Amendments to the Drawings:

Application Serial No. 10/708,745
Amendment dated January 6, 2006
Reply to Office Action dated October 6, 2005
Annotated Marked-up Drawing

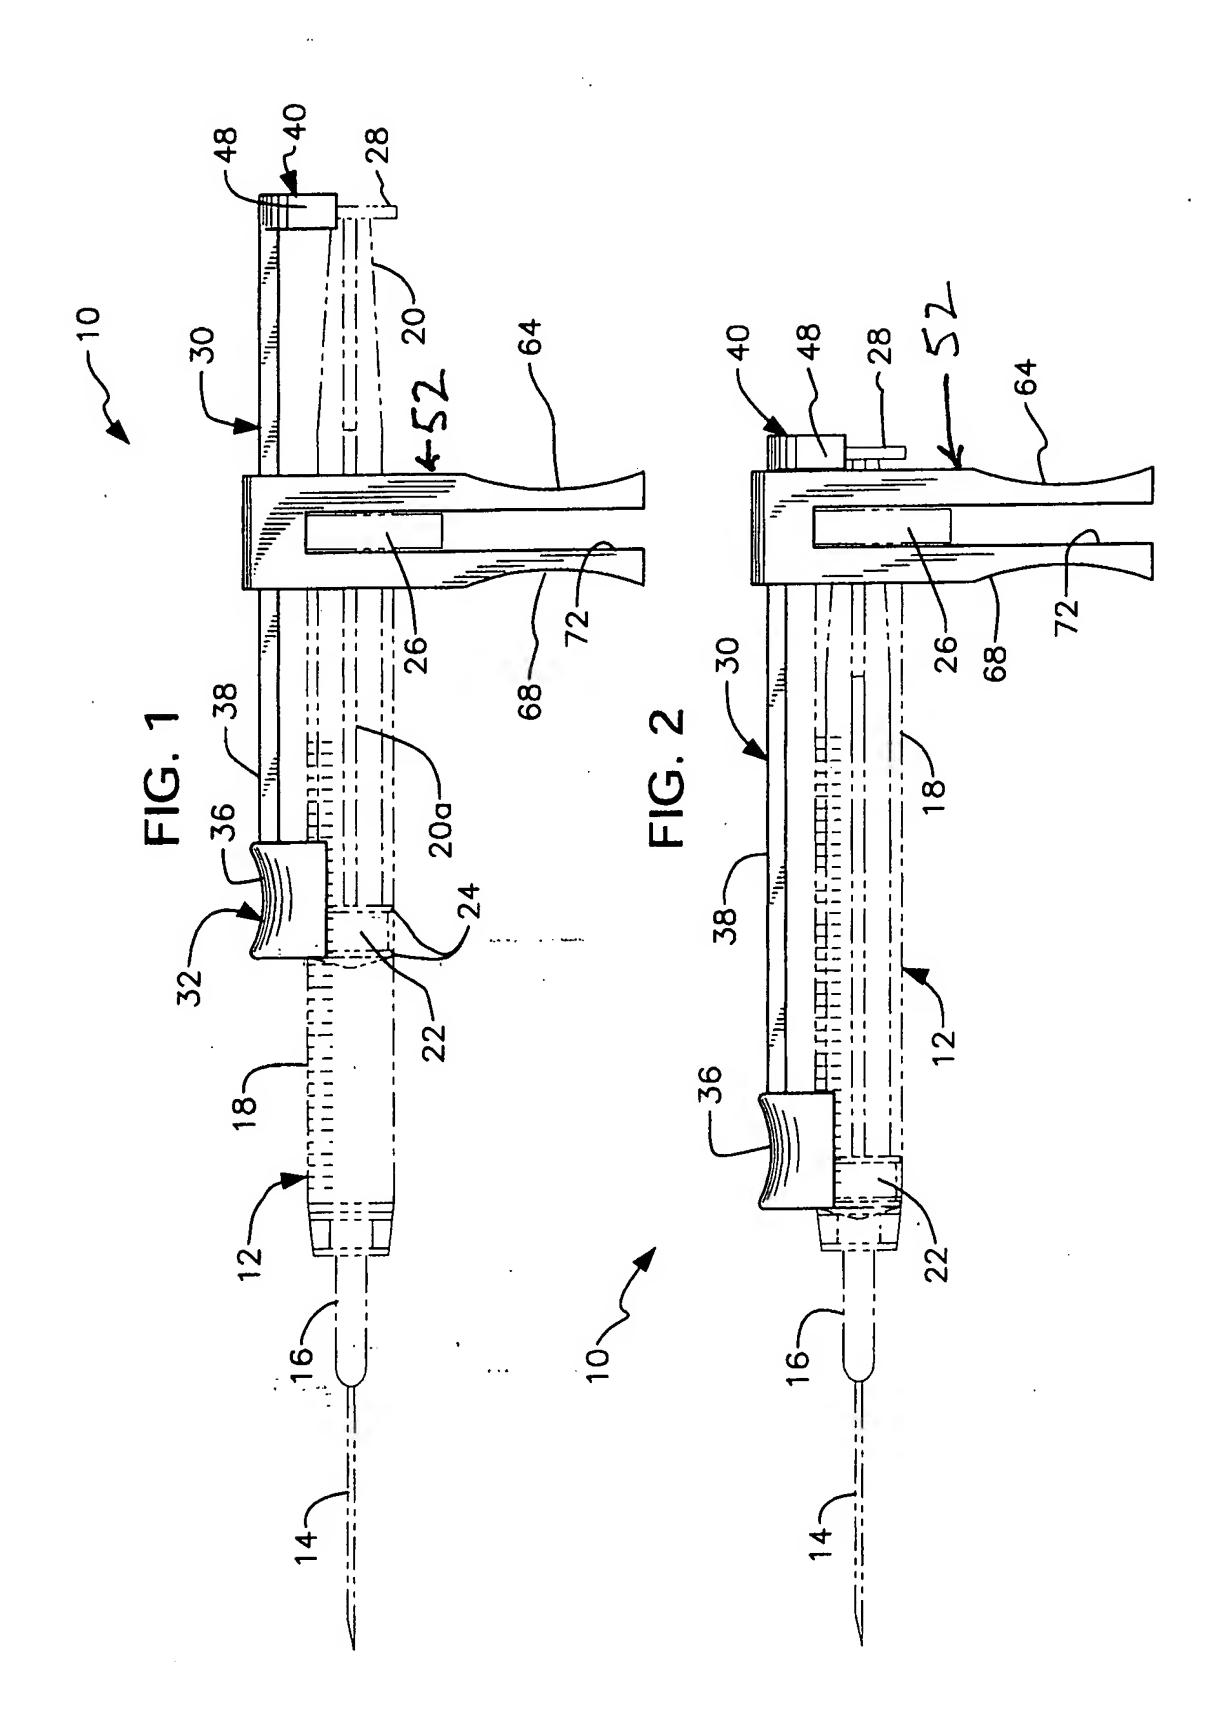
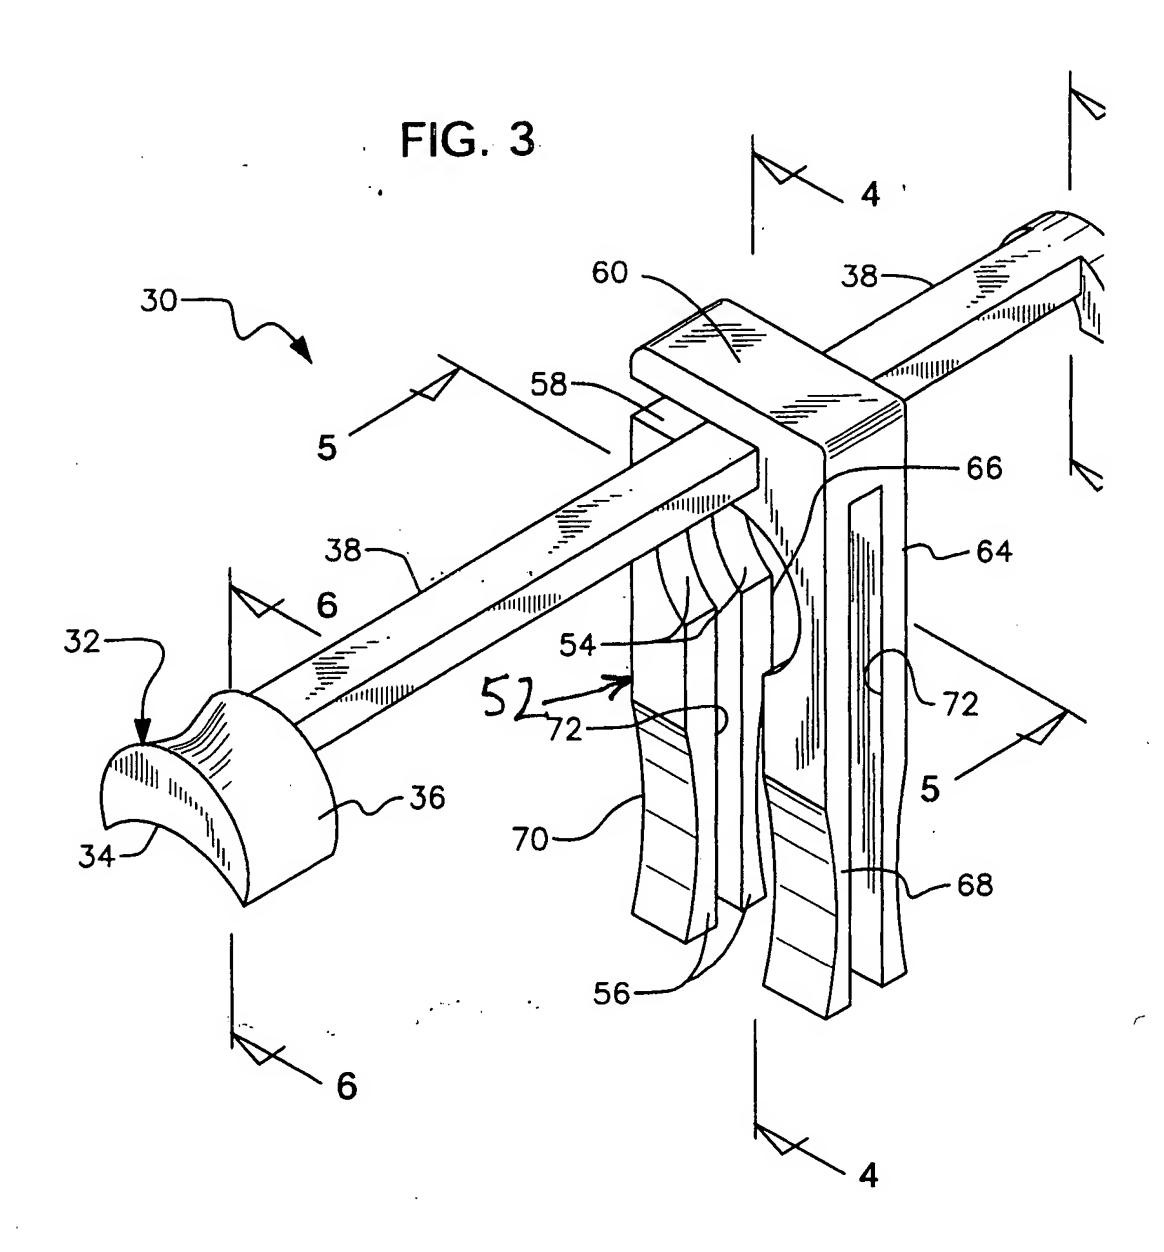
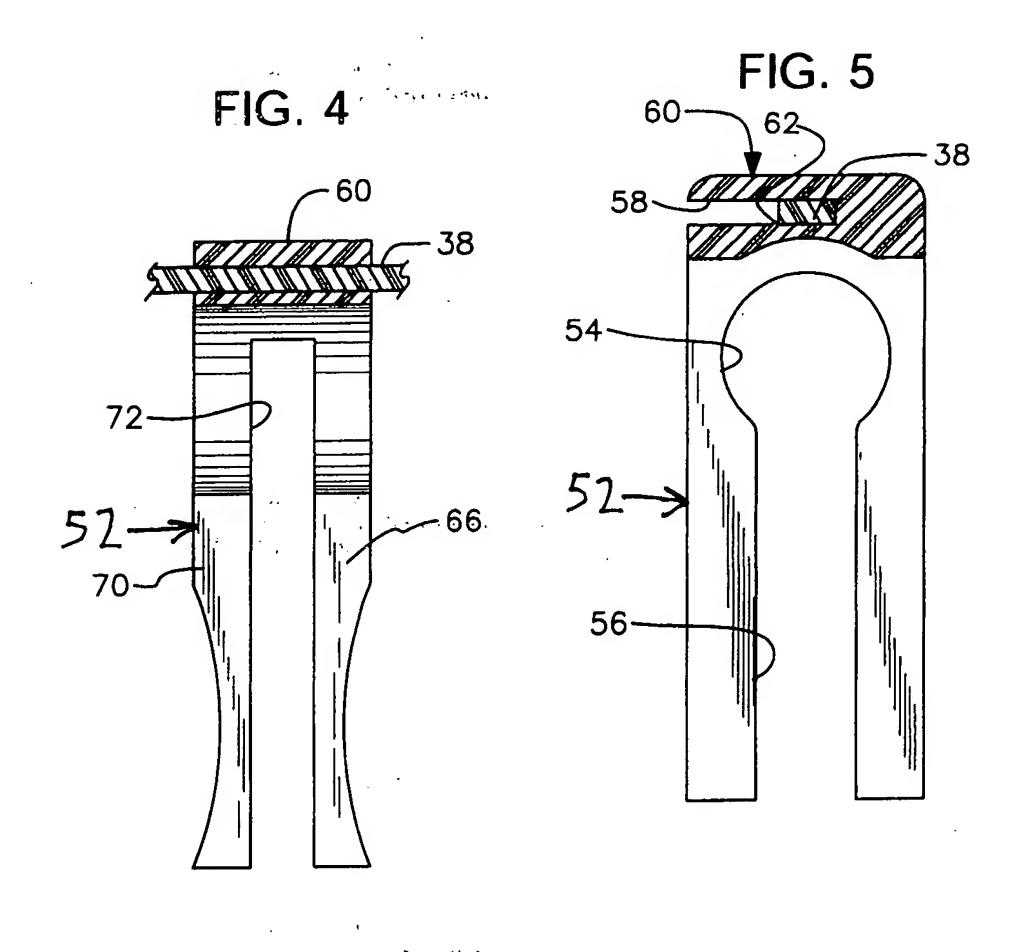
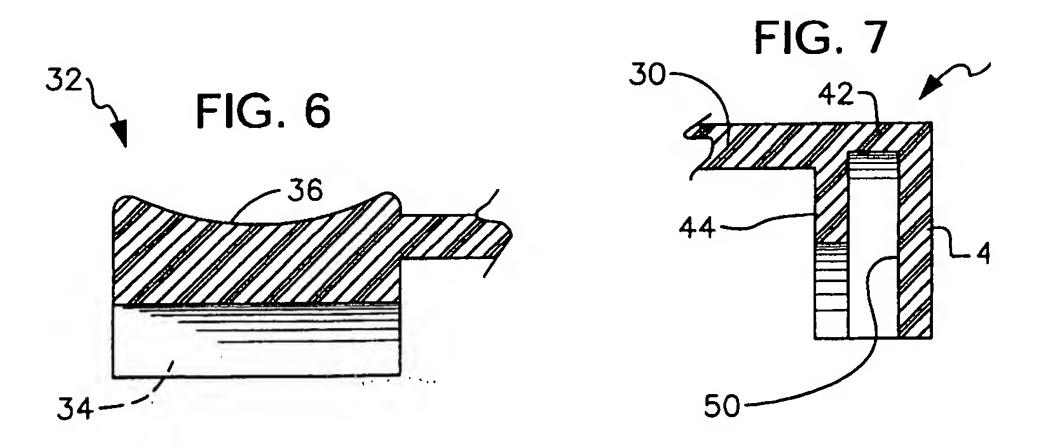
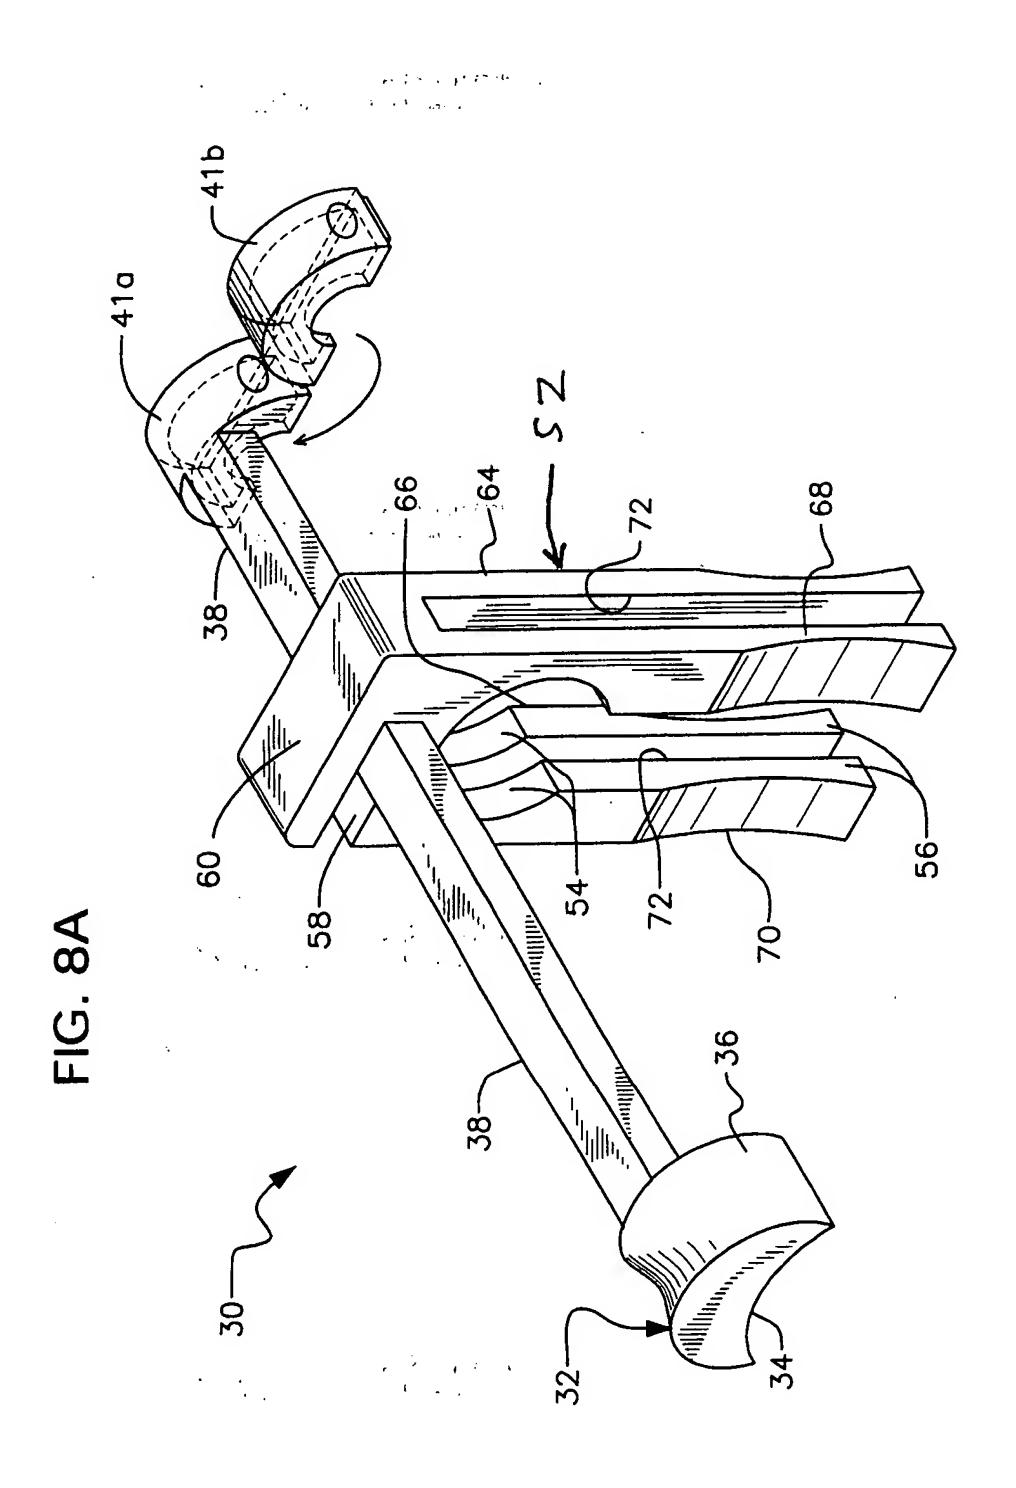
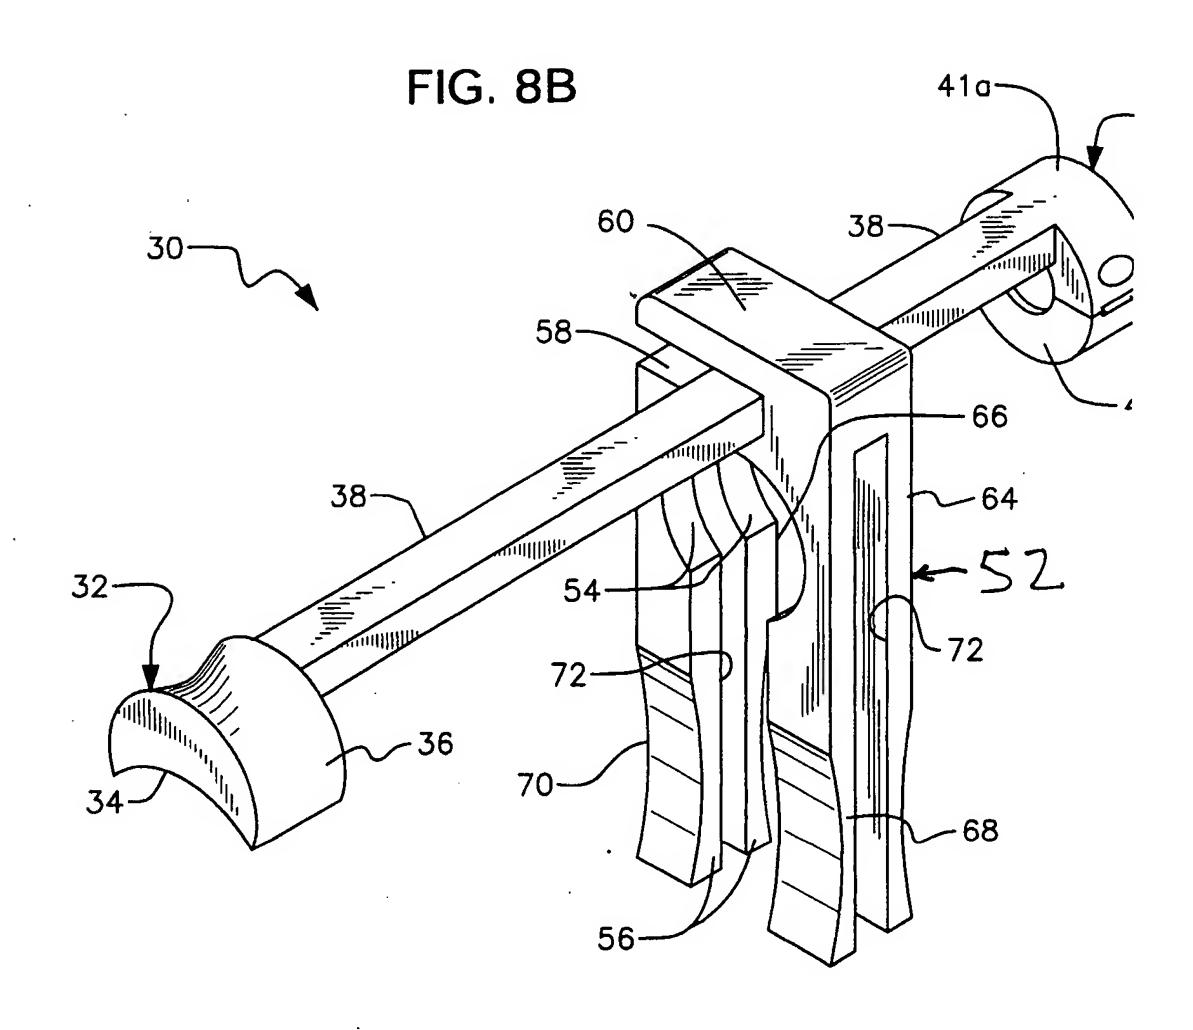
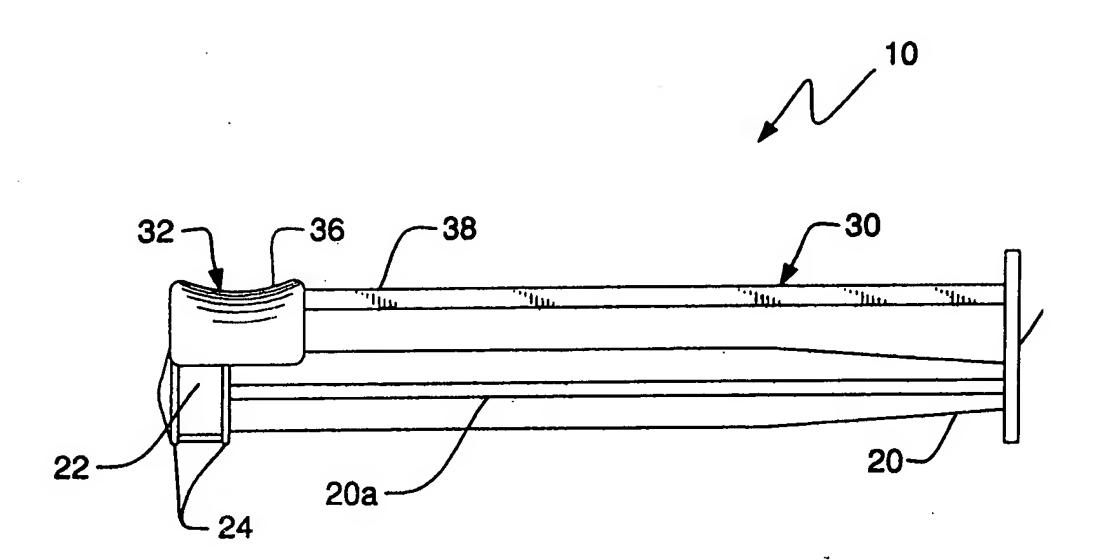
The drawings stand objected to because reference numeral 52 is missing therefrom. Applicant therefore files herewith drawing sheets indicating the correction in permanent red ink and replacement drawing sheets, in accordance with 37 CFR 1.121(d).
